DELTA CONVEYANCE

# Final Draft Project Refinements Report

August 2025

**Reference no.:** EDM\_PW\_CE\_RPT\_Proj-Refine-Rpt\_001540\_V00\_D\_20250729

**Figure 3-2. Refinement 2 Tunnel Profile between Intakes and Surge Basin**

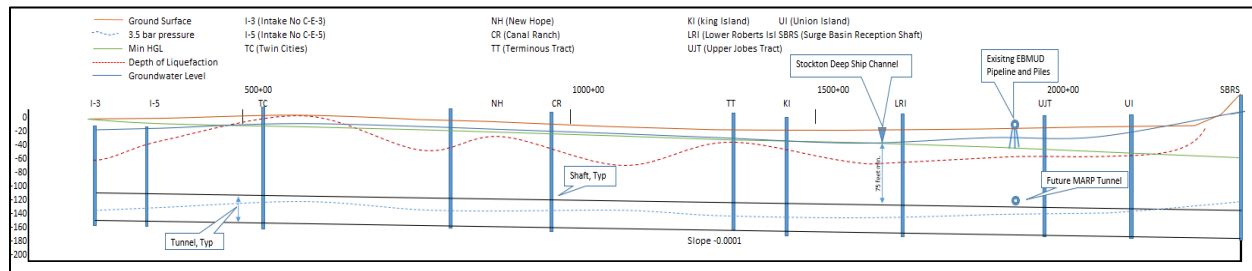
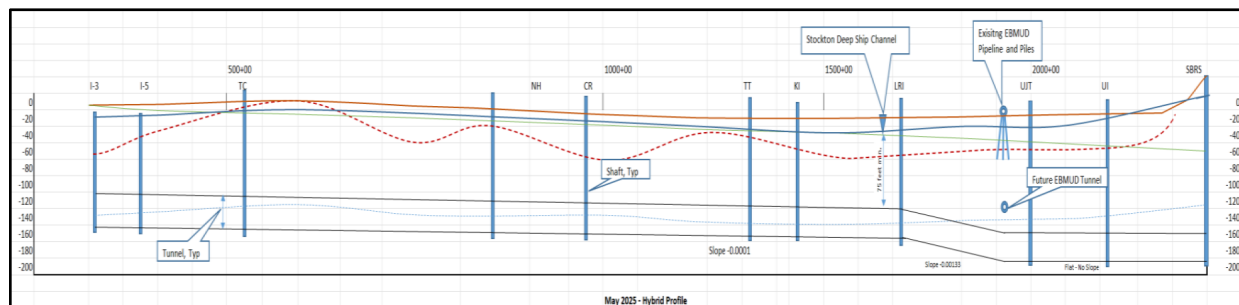
Following completion of the EPR and Final EIR, several evaluations were considered based upon available geotechnical information and standard engineering practices. The results of those studies indicated that there should be at least 20 feet between the invert of the MARP tunnel and the top of the project tunnel at the crossing. To provide this minimum separation, Refinement 2 will lower the project tunnel profile between Lower Roberts Island and the Surge Basin to avoid conflicts with the proposed MARP based upon available information. The tunnel slope would be steeper from Lower Roberts Island to just past the MARP crossing and then become flat from that location to the Surge

- Increased tunnel shaft depth at Upper Jones Tract, Union Island, and the Surge Basin.
- Decreased tunnel shaft diameter at the intakes and reception and maintenance shafts (not including the Surge Basin).
- Excavation volume for tunnel shafts (including intakes) in Sacramento County would be reduced due to the reduced tunnel shaft diameters and/or reduced invert tunnel slabs from 179,400 cubic yards to 155,600 cubic yards.
- Excavation volume would increase due to deeper tunnel shafts downstream of Lower Roberts Island. However, due to the reduced tunnel shaft diameters and/or reduced invert tunnel slabs, excavation volume would be reduced from 309,600 cubic yards to 281,150 cubic yards.
- Reduced invert slab thickness will reduce the duration of 24-hour tremie concrete pours at the intakes and reception and maintenance shafts.

Tunnel Shaft	EPR Shaft Invert	Refinement 2 Invert
Lower Roberts Island	-156.49 feet	-156.49 feet
Upper Jones Tract	-151.19 feet	-183.5 feet
Union Island	-161.43 feet	- 183.5 feet
Surge Basin	-164.18 feet	-183.5 feet

Figure 4-1. Comparison of the Bethany Reservoir Pumping Plant Schematics for EPR and Refinement 3

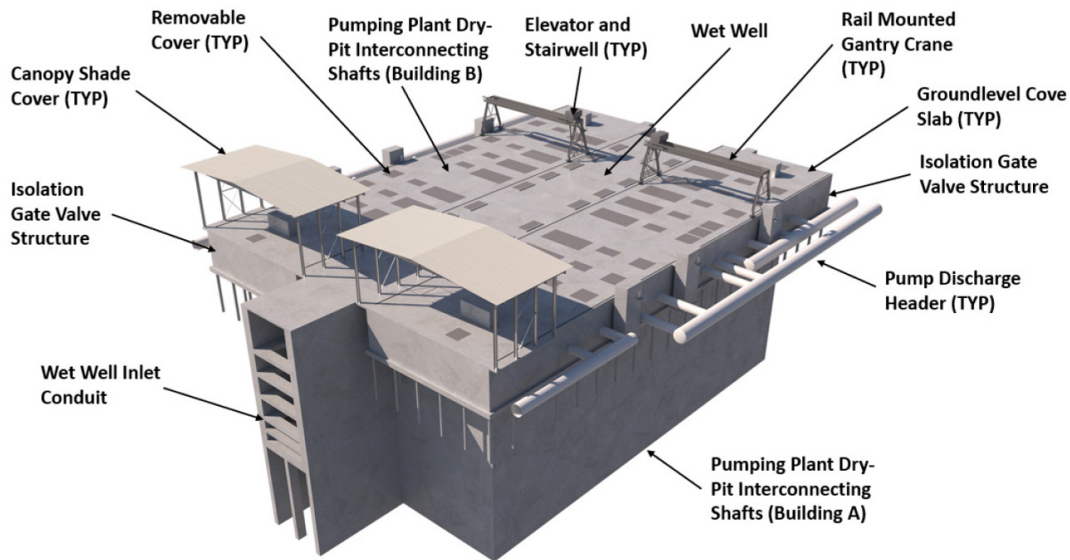
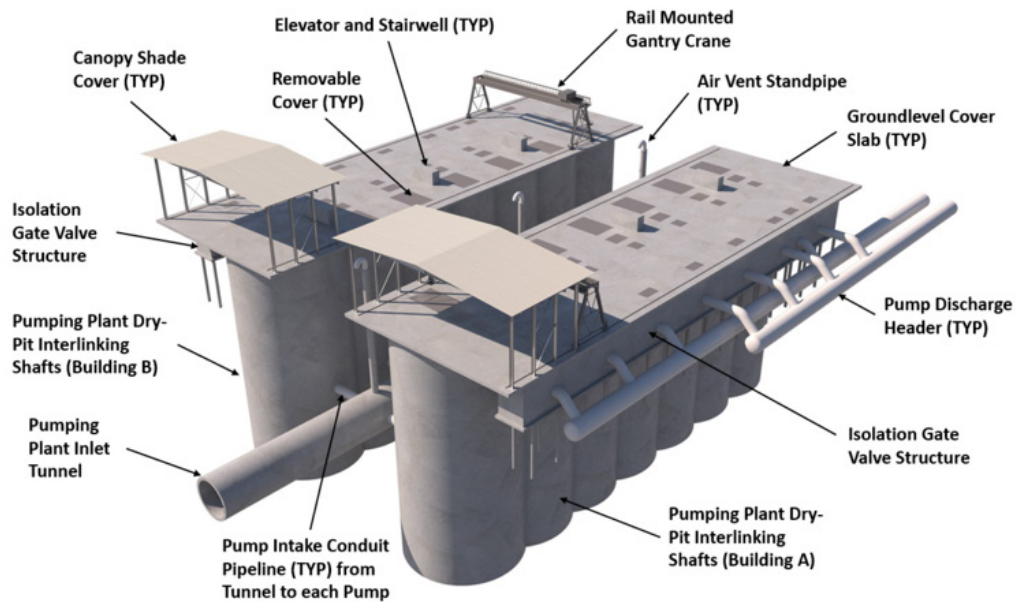
Following completion of the EPR, results from previous geotechnical investigations became available and indicated that the potential for liquefaction was less than assumed during preparation of the EPR. Therefore, under Refinement 3, the wet well will be replaced with a tunnel that will be constructed in an open-face excavation manner with a tunneling shield or using a sequential excavation method. The vertical deep-box diaphragm wall arrangement will be replaced with two underground structures using interlinking circular shaft structures on either side of the tunnel. This type of structure will have a different type of foundation that will be constructed following initial excavation to the bottom of the pumping plant up to the ground surface. This method will be more efficient and safer for construction workers and will reduce excavation soils, concrete quantities, and construction complexity.

- Improved construction worker safety because construction would occur from the bottom of the excavation to the ground surface.
- Excavation volume in San Joaquin County would be reduced from 2,797,000 cubic yards to 2,237,600 cubic yards.
- Concrete volume would be reduced from 304,300 cubic yards to 243,400 cubic yards.

**Figure 6-2. Bethany Reservoir Aqueduct Configuration in the Refinement 5**

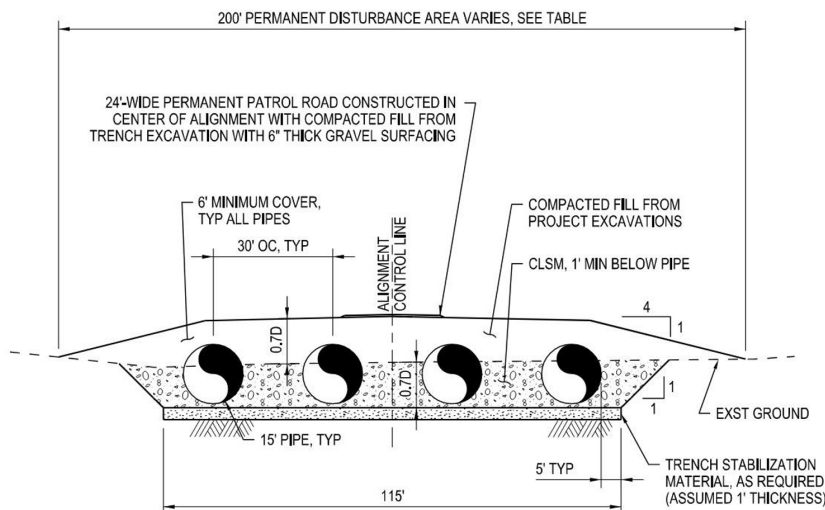
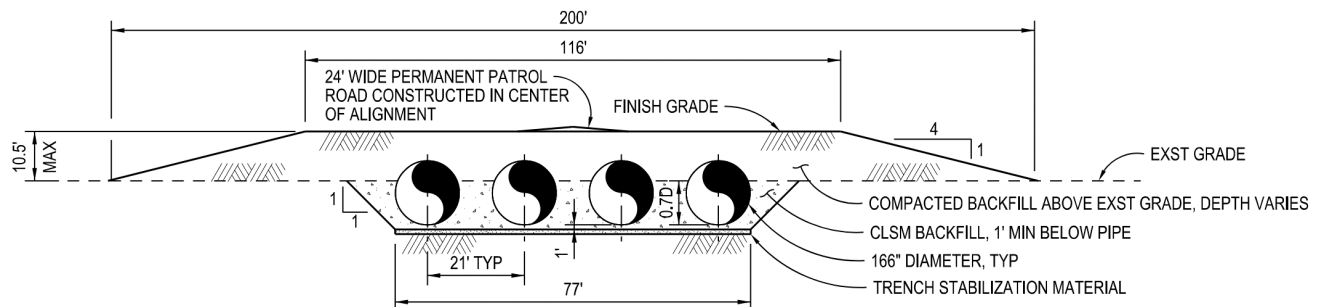
- Reduce internal diameter of the pipes from 15-feet to 13.83 feet. A portion of the reduction is related to reducing the steel pipe wall thickness from 0.75 inch to 0.69 inch, as shown in Figure 6-2.
- Reduce space between pipe centerlines from 30 feet to 21 feet and reduce the distance from the outside wall of the end pipes from the trench wall from 13 to 7.5 feet.
- Reduce the bottom width of the trench from 115 feet to 77 feet.
- Excavation will be reduced from 1,060,300 cubic yards to 842,800 cubic yards.
- Soil needed for CLSM and compacted backfill will be reduced from 1,395,550 cubic yards to 1,187,500 cubic yards.
